Application for "Other Business" OB - M

PAGE 2 OF 3		APPLICATION NO	Z-42
ORIGINAL DATE OF APPLI	CATION:	03-15-05	
APPLICANTS NAME:	GENERA	L INVESTMENTS GROU	P, INC.

GENERAL INVESTMENTS GROUP, INC. (H. Dorsey and Lou Ellen W. Summers, owners) for Rezoning from **R-20 with Stipulations** to **R-20** for the purpose of a Three-Lot Subdivision in Land Lot 185 of the 18th District. Located on the southeasterly side of Ivey Road, south of Regency Way.

Min. Bk. 33 Petition No. Z - 42
Doc. Type Site Plan

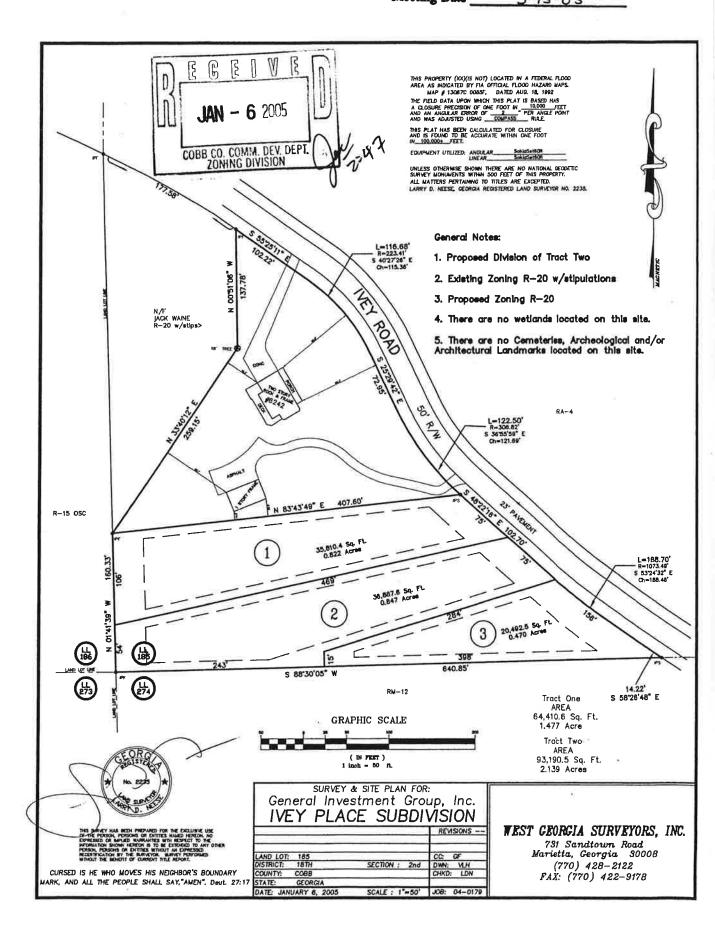
INSUFFICIENT INFORMATION ✓ No Stormwater controls shown — must be addressed at	
 ☐ Copy of survey is not current - Additional comments mare exposed. ☐ No site improvements showing on exhibit. 	nay be forthcoming when current site conditions
ADDITIONAL COMMENTS/SUGGESTIONS 1) Tract perimeter does not conform to tax map dating to same for both this tract and that to north) built detact property line. Resultant change compromises this tract. 2) The tract under consideration is dominated by 150	thed garage over line resulting in need to change ct.
· · · · · · · · · · · · · · · · · · ·	-Tool wide ridge of gentle to moderate ground

- 2) The tract under consideration is dominated by 150-foot wide ridge of gentle to moderate ground slopes running parallel and adjacent to Ivey Road, and, in rear by very steep hillside ranging from 34% to 46%. The selected property change described above removed approximately 200-foot of road frontage and 75-foot of ridge from the tract as platted by the tax maps. The only allowable sites for house construction is along the ridge near the road. The resultant lots are narrow and restricted in the available building area. Construction of housing, similar to those two (2) to the north, could be quite challenging.

- 3) Originally, with the two houses to north and the one designated for this tract, there were to be three (3) houses on this gross triangle. Now, with this application there would be five (5). That represents a 67% increase in runoff and pollution. There is no Water Quality-Best Management Practice, nor detentions proposed here to mitigate the impact on downstream. There is no viable channel into which a detention system could discharge.

- Providing detention and water quality here would be overly expensive and technically challenging. Alternatively, recommend developer pay fee in lieu of detention, and, restrict improvement hard surface to 25% of an R-20 lot size (5000 square feet impervious; approximately equal to the improvements to north), and, require roof water to discharge to lawn at structure and be created as sheet flow a minimum of 50 horizontal feet across vegetated area before leaving property.

Note Ivey Road to be a rural section with roadside ditches. Driveway water must be directed to those ditches and not onto Ivey Road travel surface.

- 4) Tract is heavily wooded. Tree removal must be limited to only those within the footprint of house and nominally 10-feet to 20-feet outside to minimize the loss of benefits now provided by the trees.
- 5) Each lot must submit a Site Plan demonstrating conformance with these comments to Stormwater Management for review and approval prior to building permit.

Install sidewalk, curb and gutter along the frontage.

The applicant will have to verify that minimum intersection sight distance is available. If it is not, the applicant will have to implement remedial measures, subject to approval by the Department, to achieve the minimum requirement of 200'.

Recommend installing sidewalk, curb and gutter along the road frontage.

Recommend applicant verify that minimum intersection sight distance is available and if it is not, implement remedial measures, subject to the Department's approval, to achieve the minimum requirement of 200'.
